Rich Miller
Systems engineering

Re: Permissive change of STRATA TXU, TCU FCC ID. #
FC3STATXU2D

**CHANNEL A1r SPECTRAL MASK CFR 47 PART
74 (a)**

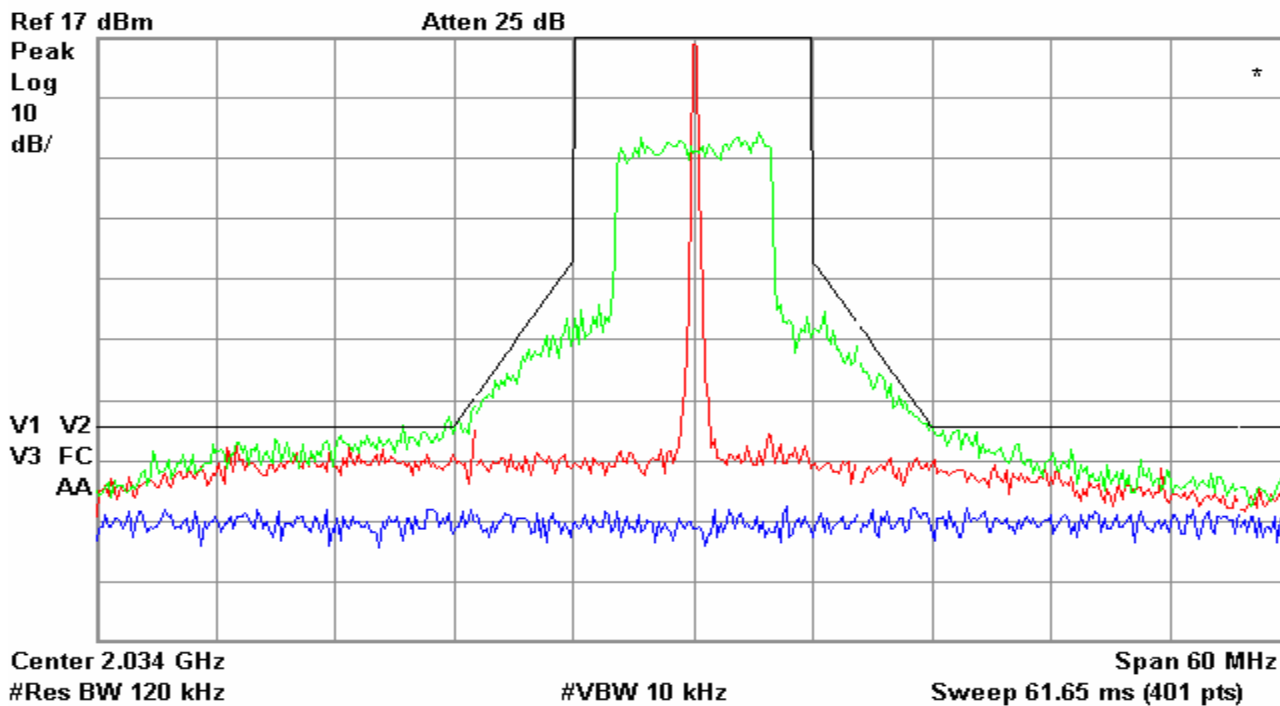
**THIS PLOT WAS COPIED FROM THE PERMISSIVE
CHANGE DATA I PROVIDED FOR THE 12 MHz BAS
CHANNEL BANDWIDTH SHOWING COMPLIANCE
AT 28DBM**

***2033.5MHz .6 WATTS 28dbm QPSK 8 MHz FEC1/2 GUARD
INTERVAL 1/8 10dbm attenuator 1dbm cable loss***
